Enhancements to Initialization Procedure

Sept '05 Presentation to Ethernet over Backplane working group
Joe Abler
Rob Brink

10GBASE-KR Training Signaling Using PRBS-7

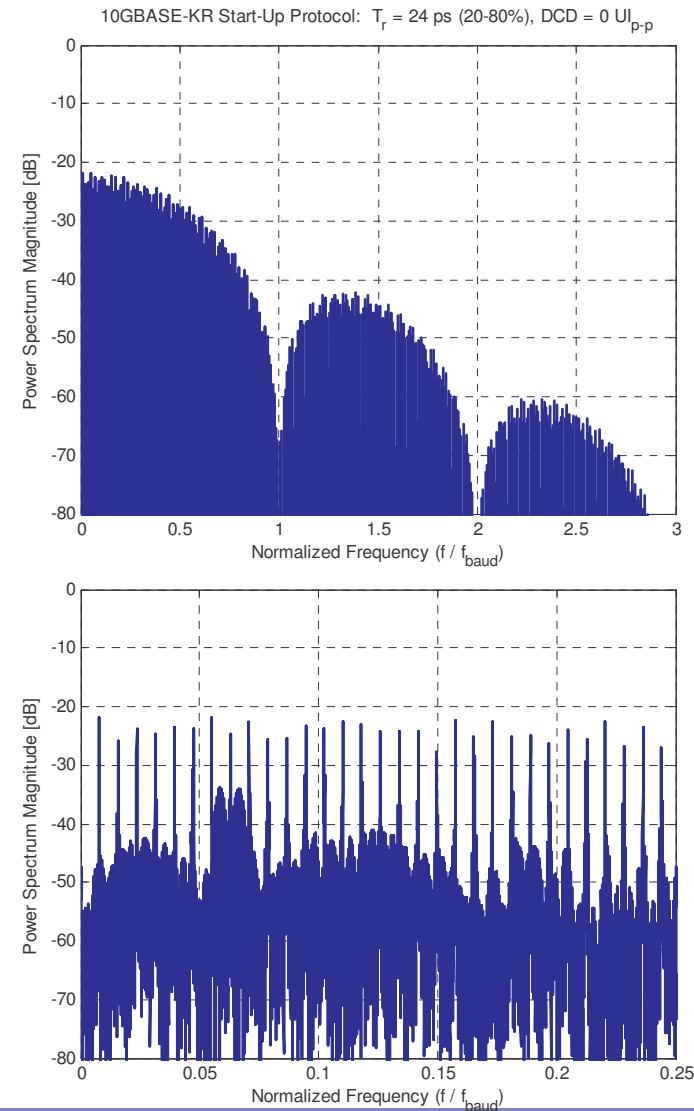
- 4-octet frame marker
- 32-octet control channel
- 512-octet training pattern
 - PRBS-7 ($x^7 + x^6 + 1$)
- Spectral peaking attributed to repetition of PRBS-7 in the training field

Change Training Pattern to PRBS-11

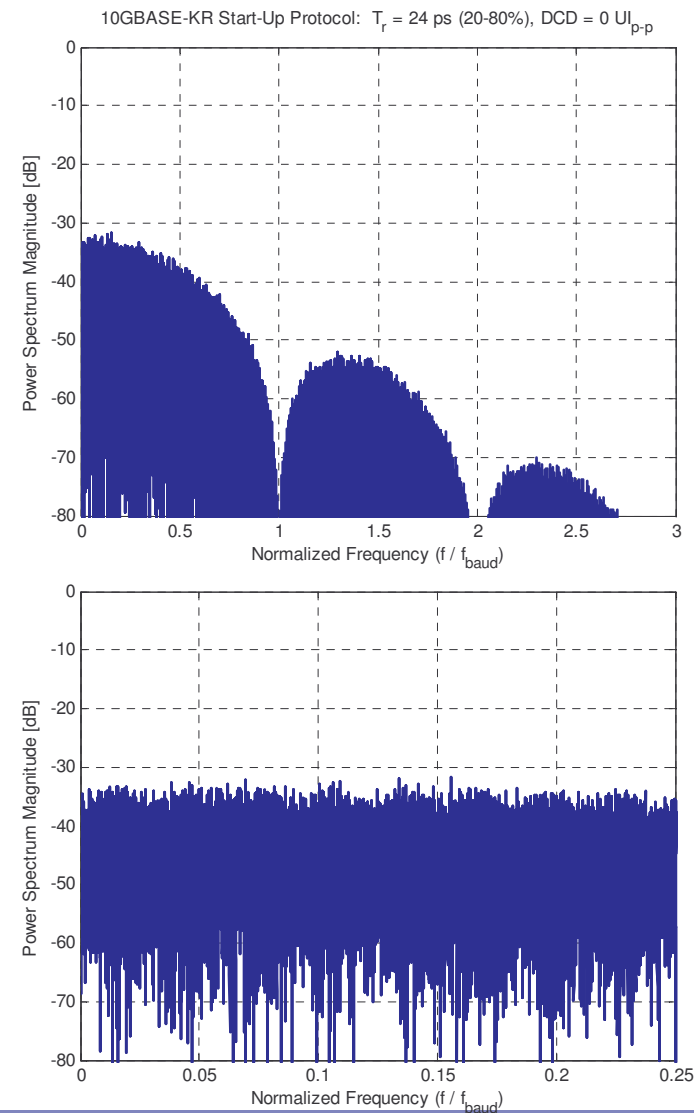
- 4-octet frame marker
- 32-octet control channel
- 512-octet training pattern
 - PRBS-11 ($x^{11} + x^9 + 1$)
- Longer PRBS polynomial reduces peaking by ~10dB

- **Increase training pattern length to 512 Octets**
- **Change training pattern to PRBS11**
 - 1 seed at start of each iteration
 - Final 2 bits of 512 Octet field set to '00'b
